## WATER RIGHT PERMIT APPLICATION REVIEW

*Interoffice Memorandum*

**To:** Lisa Graham and Scott Ceciliani  
**From:** Joe Kemper  
**Subject:** Groundwater Concerns for Proposed Reservoir R-89194

# Site Map

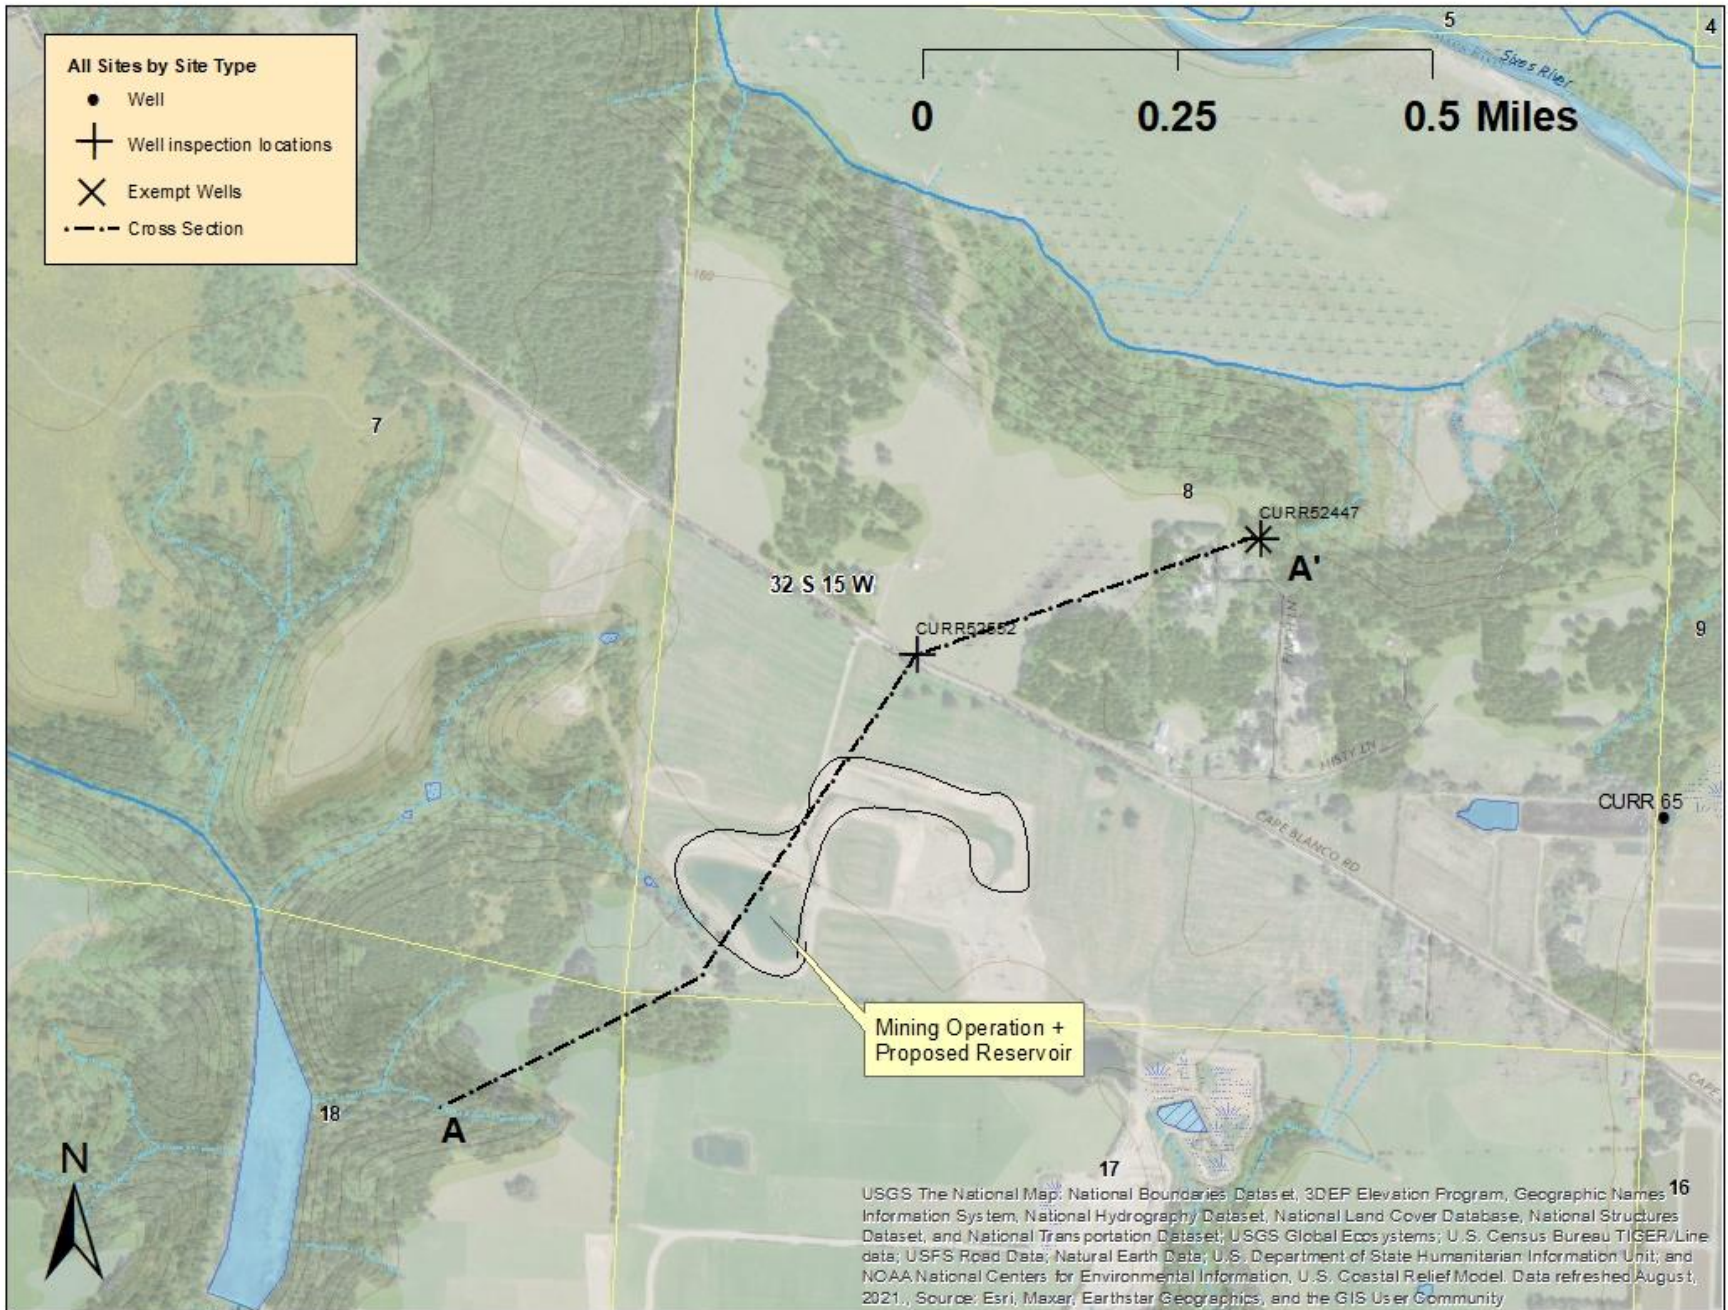
**Problem statement:** OWRD staff are concerned that the contributing surface water drainage is not sufficient to fill the reservoir under application R-8919 (See OWRD's WRIS database for water right details). The proposed reservoir may be deep enough to intersect the water table, which would allow groundwater to flow into the reservoir. If true, this creates two specific problems: 1) the source of water, wholly or in part, is groundwater rather than surface water and would require a groundwater right and 2) daylighting groundwater in such pits allows for significant amounts of evaporation from the water surface.

- The excavated reservoir for R-89194 is the location of a surface mining operation under DOGAMI ID# 08-0082 (McKenzie Site). Permitting details available at this time do not discuss groundwater concerns e.g. anticipated need for dewatering.

- Excavation depth: > 50% is 20-22 feet below land surface.
  - Elevation of excavation bottom: 145 ft amsl - source LIDAR.
- The site geology is characterized by the following:

- The excavation accesses only the Pioneer Terrace sediments to a depth of 145 amsl.
- The water table in the sediments is at 158-171 feet amsl. Degree of seasonal fluctuation is unknown.
- Based on available information, the excavation or proposed reservoir appears to intersect the water table and captures groundwater from the adjacent aquifer. Beneficial use from the reservoir would thus produce from groundwater, not just stored surface water.

# Observation Well Data

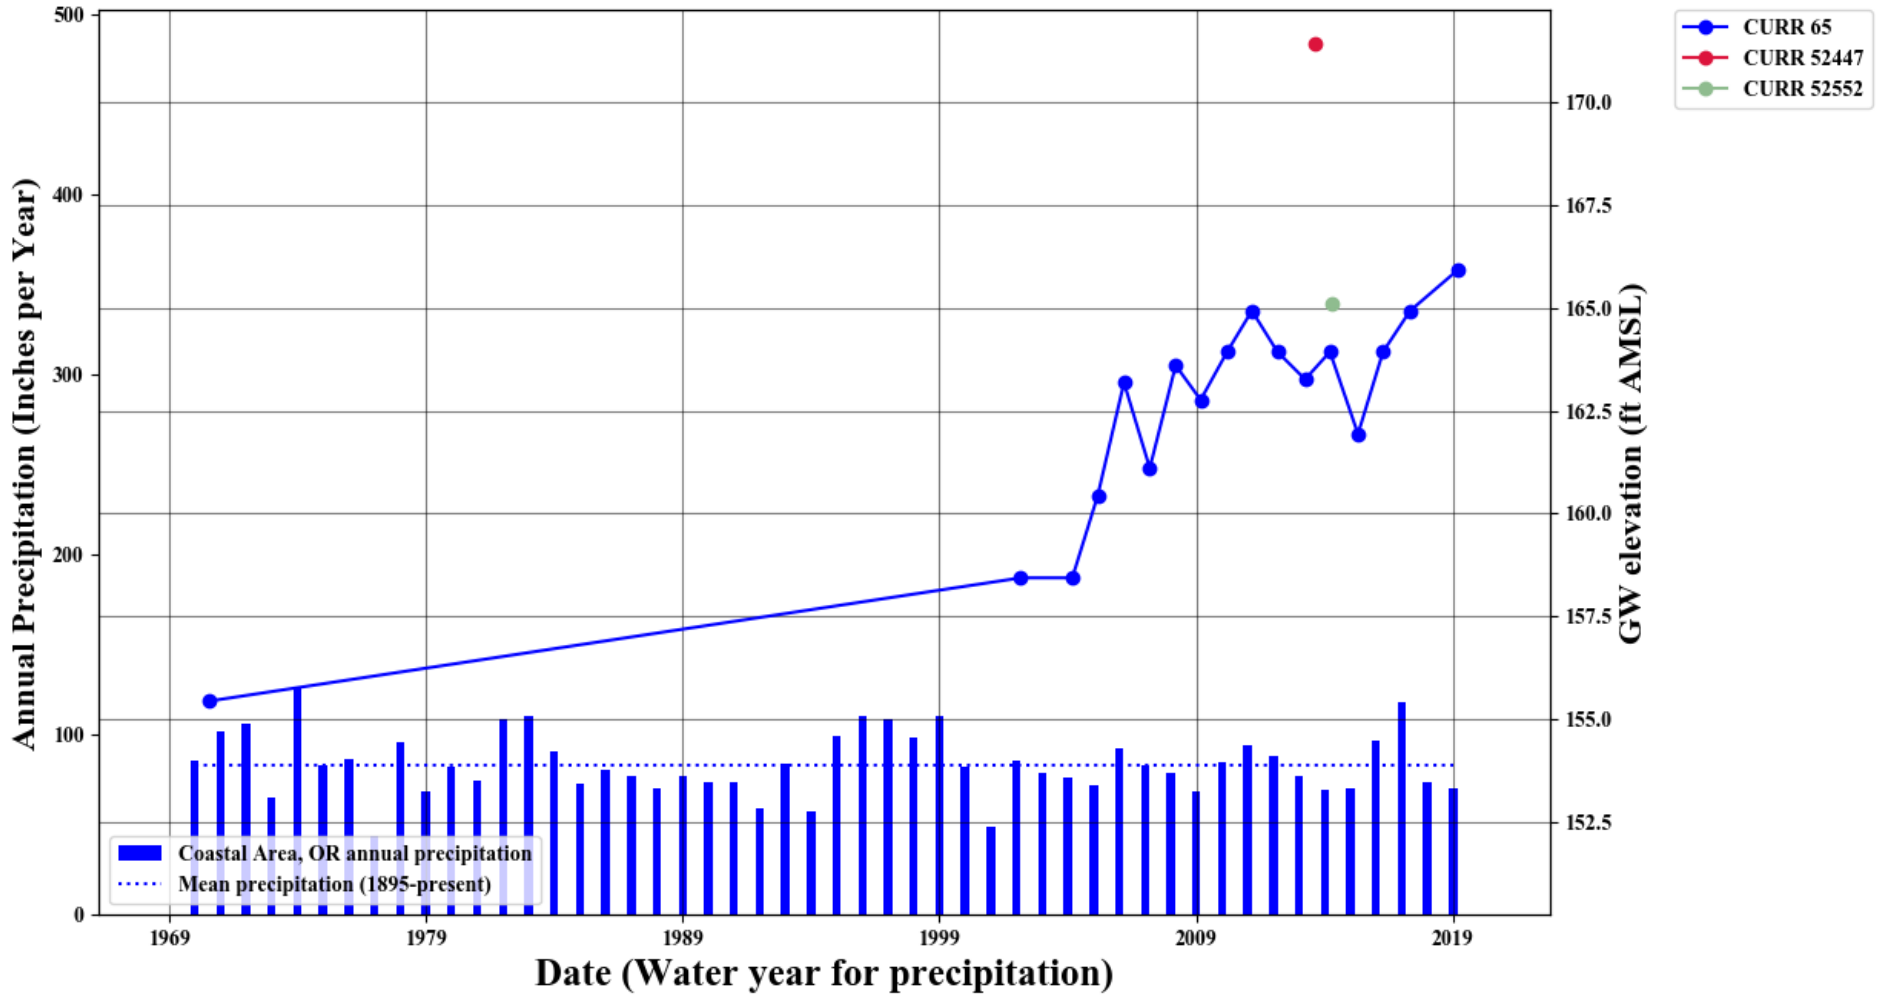
- Elevation of excavation bottom: 145 ft amsl - source LIDAR.
- Water level elevation data:
  - CURR 52447: wellhead elevation = 189.4 ft amsl; wl blsd = 18; wl elev = 171.4; located 0.5 mi NE.

- CURR 52552: wellhead elevation = 182.6 ft amsl; wl blsd = 17.5; wl elev = 165.1 ; located <1000 ft to N.
  - CURR 65: wellhead elevation = 188.43 ft amsl; wl blsd = 20-30 ft; wl elev = 158-165; ~4000 ft ENE.
